Comparison of an Ultrasonic Phased Array Evaluation with Destructive Analysis of a Documented Leak Path in a Nozzle Removed from Service

AD Cinson, SL Crawford, PJ MacFarlan, BD Hanson, and RA Mathews
Pacific Northwest National Laboratory¹, Richland, WA, USA

Figure 4 – C-scan plan view of the boric acid deposits in the interference fit region. The horizontal axis represents the circumferential range of 60–240 degrees.

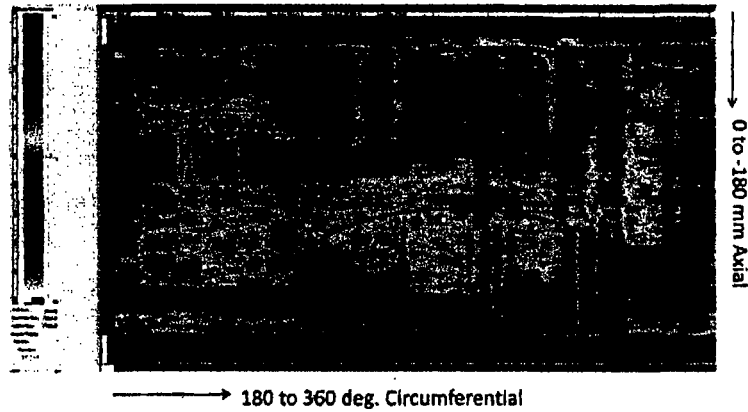
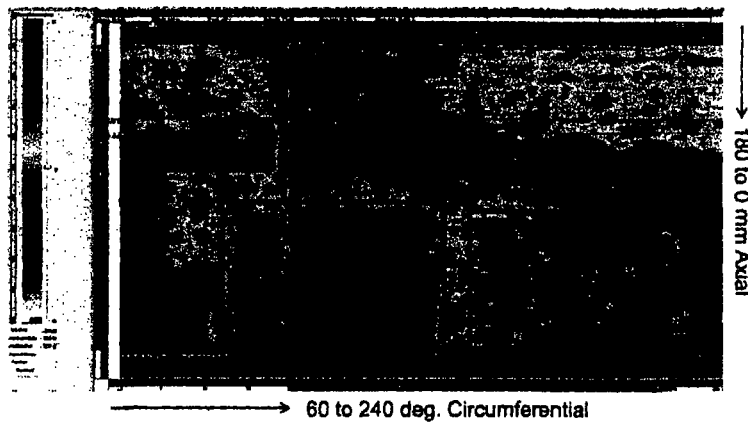
Comment [PG09]: State the purpose of the test and determine feasibility of the test system to be used. Provide a list of test conditions that would be associated with the test. Provide a list of test results and a list of test results that would be associated with the test. Provide a list of test results that would be associated with the test. Describe the basic setup/configuration of the test. Provide a list of test results and a list of test results that would be associated with the test. Otherwise it is difficult to understand the description of boric acid deposits.

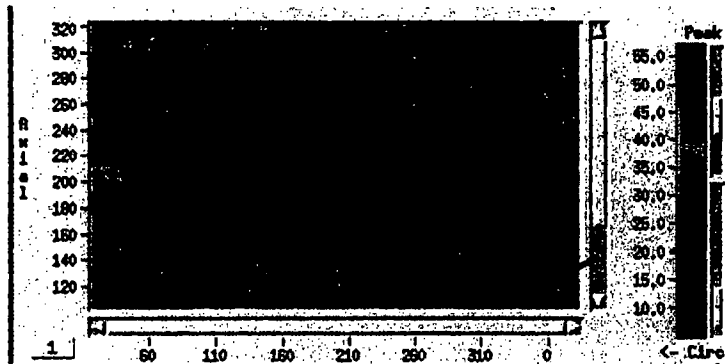
Comment [P0011]: Confirm you have permission to use this figure and make publically available.
